**RE: PROPOSED MAJOR PROJECT APPLICATIONS MP 10\_0149 & MP 10\_0150  
20 EDWARD STREET, NORTH SYDNEY (GRAYTHWAITE)  
AMENDED PROPOSAL AND REVISED EA**

**APPLICATION No:** **PART 3A DEVELOPMENT** - Department of Planning  
Reference: MP 10\_0149; MP 10\_0150

**PROPOSAL:** Concept Plan application for Staged Development comprising the conservation and refurbishment of the Graythwaite House, parking and access works, development of additional buildings and associated demolition, and Project Application for Stage 1 including conservation and refurbishment works to existing buildings, stormwater improvements, landscaping, parking and access improvements.

B. View with Proposed West Building and Weed Vegetation Removed

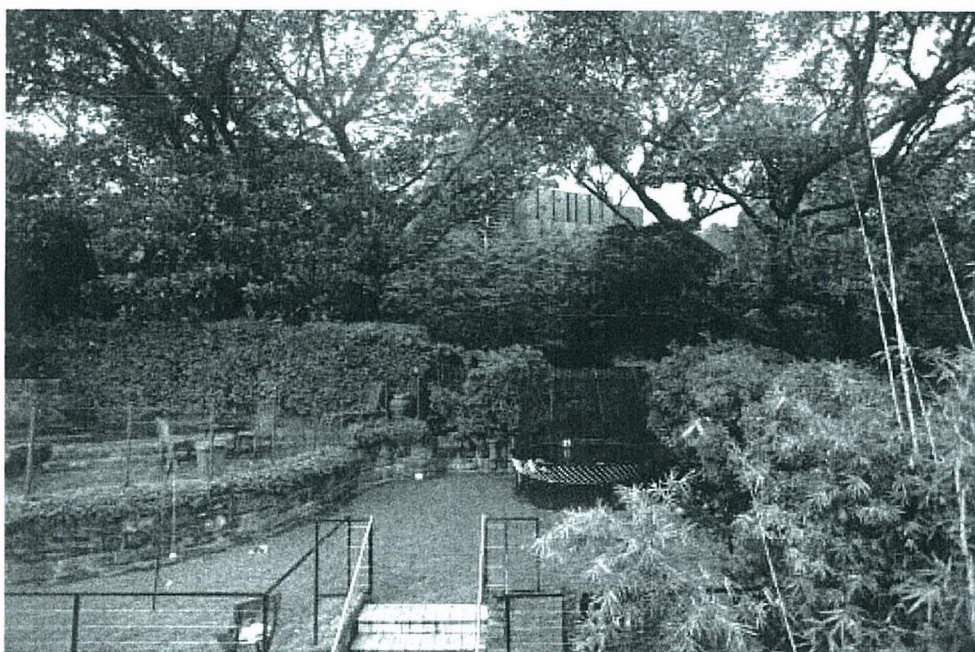
The proposed west building has a maximum height of approximately 12m and steps down to the west. The building has a setback of 20.8m to 27.8m from the western side boundary of the site at Levels 1 & 2 then steps back at Level 3 to 27m-32.5m, with the 4<sup>th</sup> level set back 32.5m to 33.7m from the western boundary. The uppermost level (5<sup>th</sup> level) is set back 26.9m to 33.6m from the western boundary. The West Building will read as a stepped 4 storey building from the adjoining dwellings to the west of the site, in Bank Street, with the upper two levels having a greater setback but remaining visible. Existing landscaping includes a number of Fig Trees adjacent to the western boundary of the site.

A number of dwellings are located immediately to the west of the proposed West Building, at Nos.25-37 Bank Street. These dwellings have their rear yards adjoining the boundary with the development site. The following photomontages show the visual impact of the proposed West Building on No.31 Bank Street, with and without additional landscaping:
